5 March 2018

Our Ref: P-16188

RE: 2017SCL055 DA | 552 TO 568 OXFORD STREET, BONDI JUNCTION

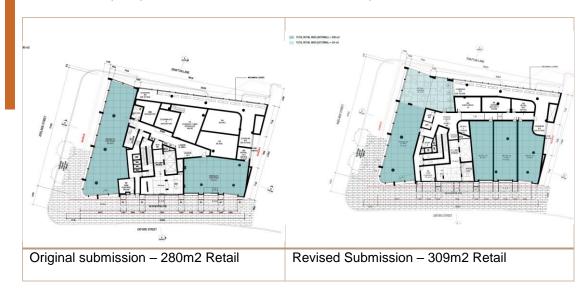
Deferral item 4 requires the relocation of plant room from the ground floor. UP Architects/Kann Finch has relocated as much of the plant room from the ground floor as is possible. For example, 2 x 80,000L water tanks were relocated to Basement Level 4. The Stormwater detention tanks/rainwater tanks were relocated to partially subterranean (Lower Ground level) as these are required to be above the invert level and so could not be situated any lower.
